1 SECOND FLOOR RCP - NORTH
1/8" = 1'-0"

<div>▲</div> ADDENDUM 1		April 7, 2017	CONSULTANTS:		<div>ARCHITECT-OF-RECORD THOMAS H. GYLLSTROM</div> <div>FL REG. NO. 9598</div> <div></div>		ARCHITECT/ENGINEERS:		<div>Drawing Title</div> <div>LEVEL 2 - AREA A - REFLECTED CEILING PLAN</div> <div>Approved: Project Director</div>		<div>Project Title</div> <div>VAMC AT LAKE NONA BUILD NEW RESEARCH SPACE</div> <div>Location Orlando, Florida</div> <div><div>Date JUNE 17, 2016</div><div>Checked TW</div><div>Drawn JH</div></div>		<div>Project Number</div> <div>675-900</div> <div>Building Number</div> <div>13</div> <div>Drawing Number</div> <div>S-AI122A</div> <div>22 OF 176</div>		<div>Office of Construction and Facilities Management</div> <div> Department of Veterans Affairs</div>	
							<div>AKEA INC.</div> <div>3603 NW 98th Street, Suite B Gainesville, FL 32606 Phone: (352) 474-6124 Fax: (352) 474-6324 AKEA Project No. 039-12</div>

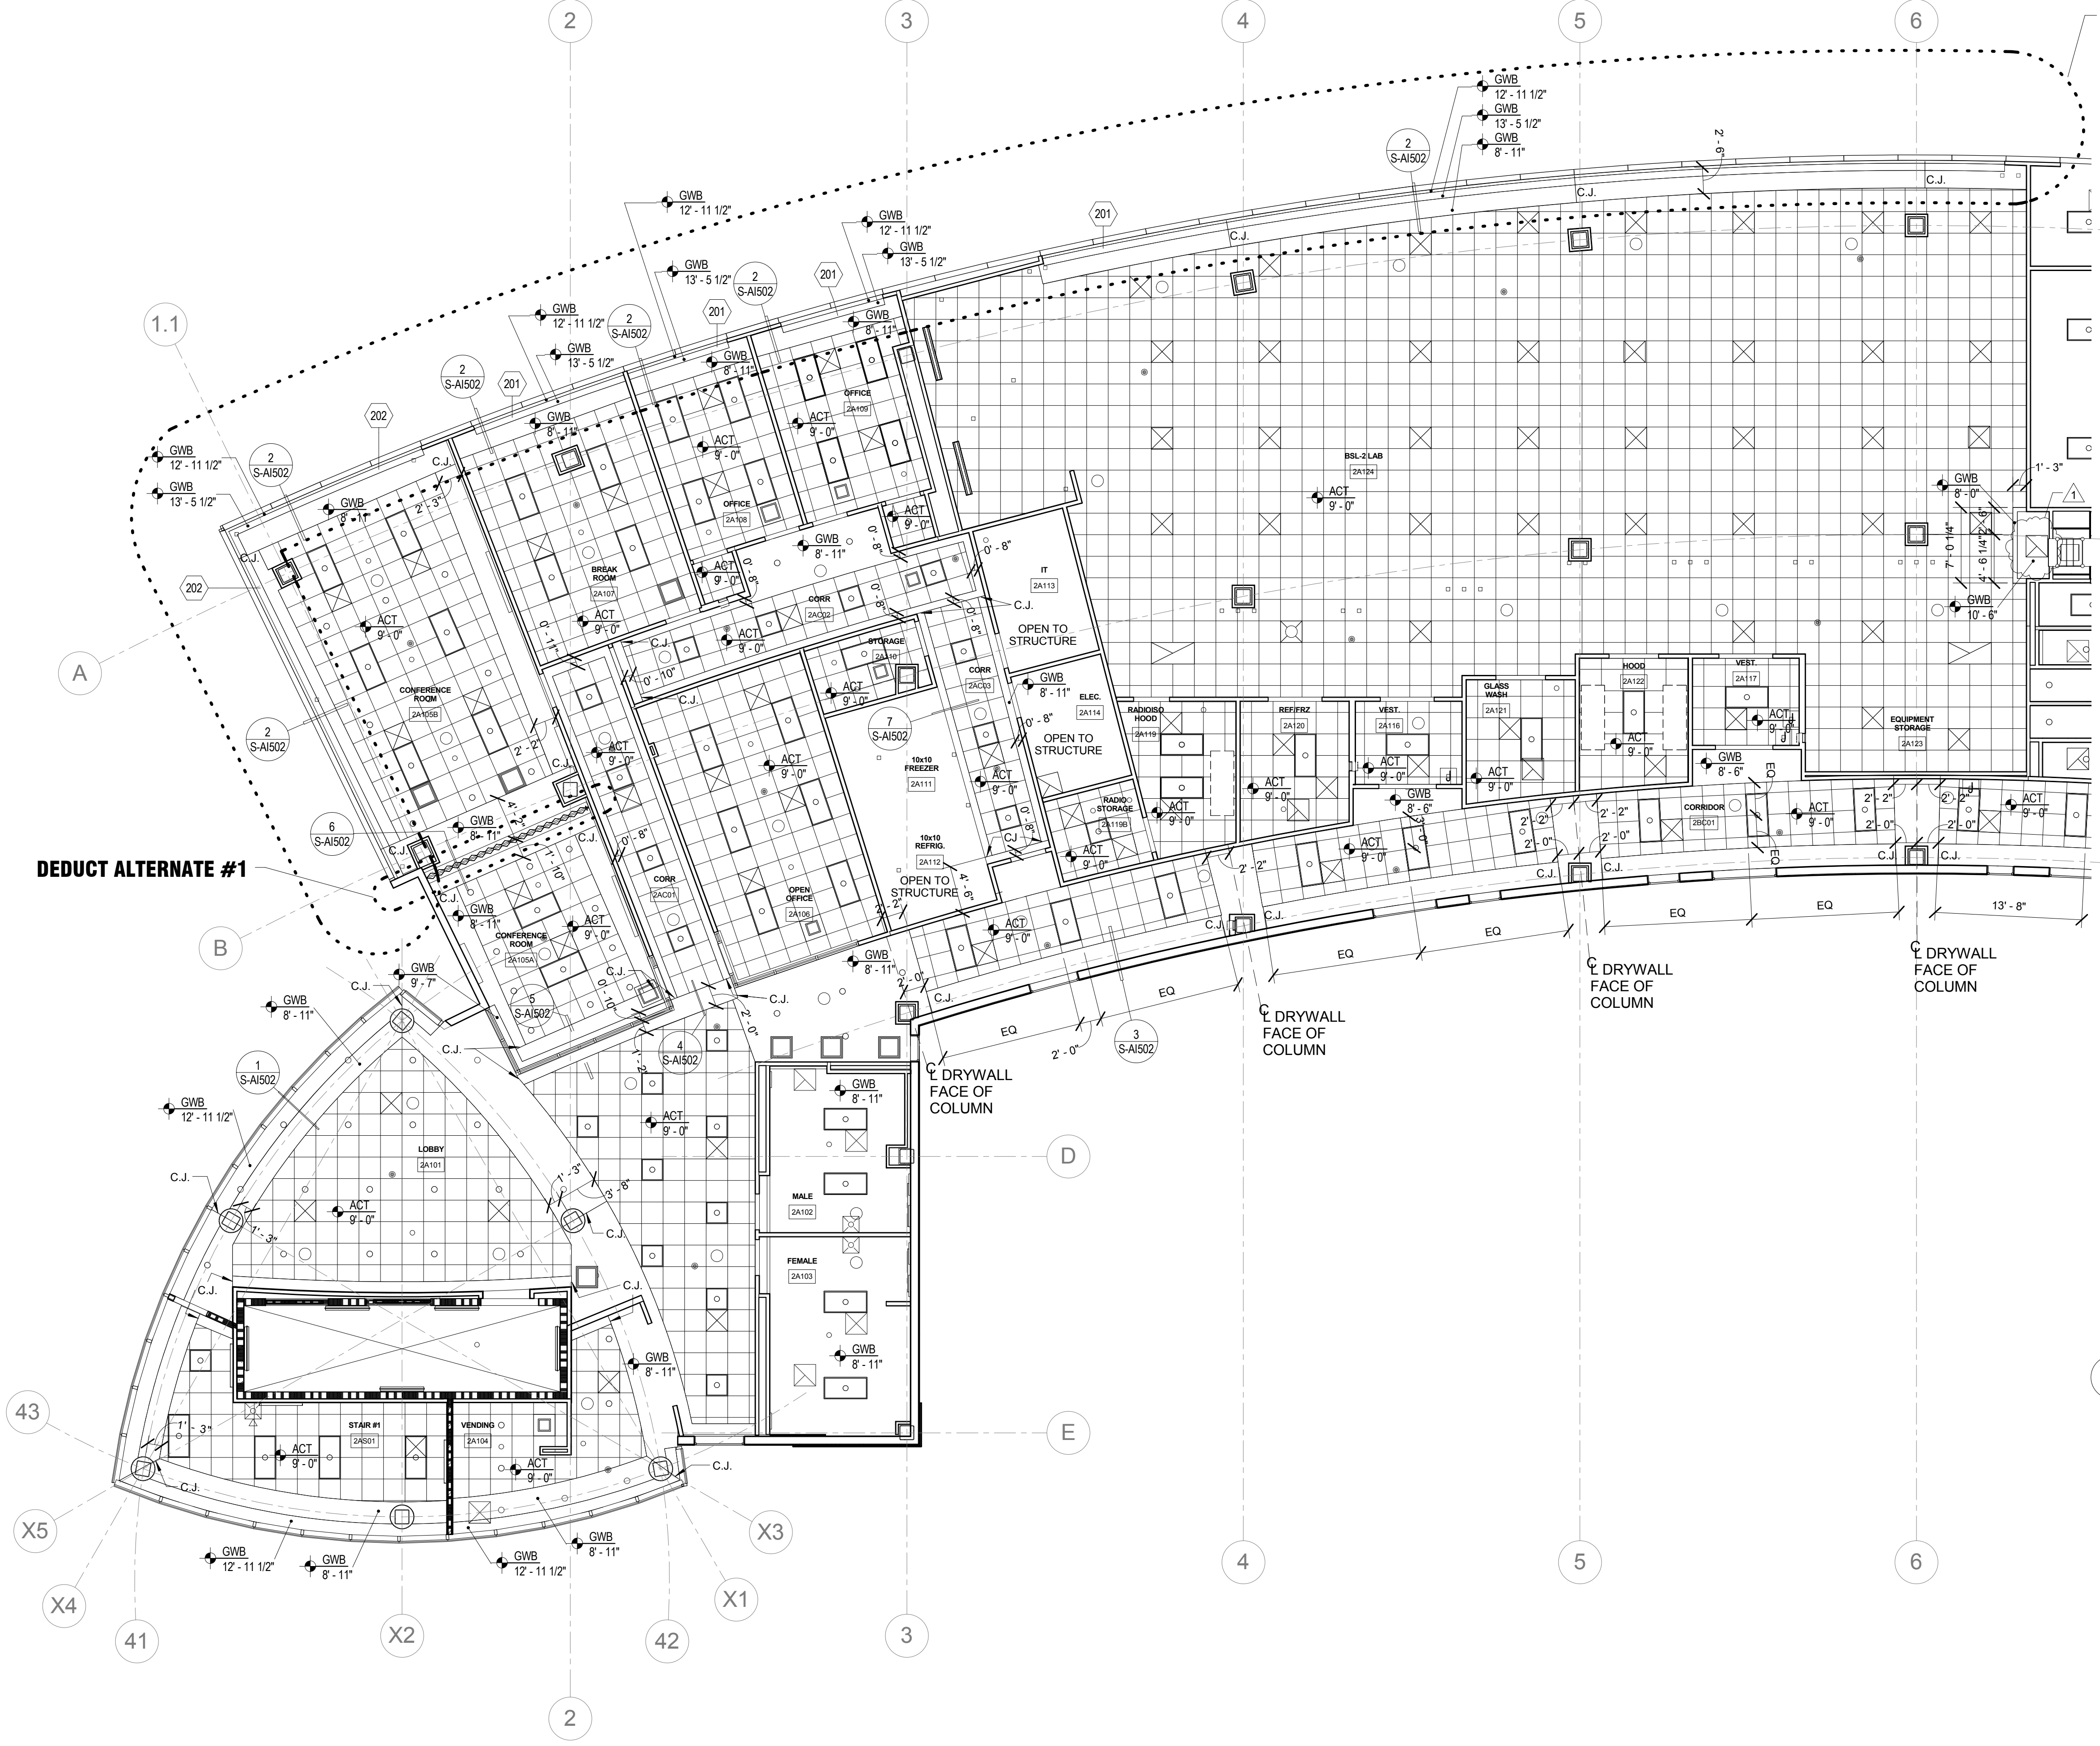
DEDUCT ALTERNATE #7
OMIT GYPSUM BOARD SOFFIT AT EXTERIOR WALL. EXTEND ACT TO WALL INSTEAD.
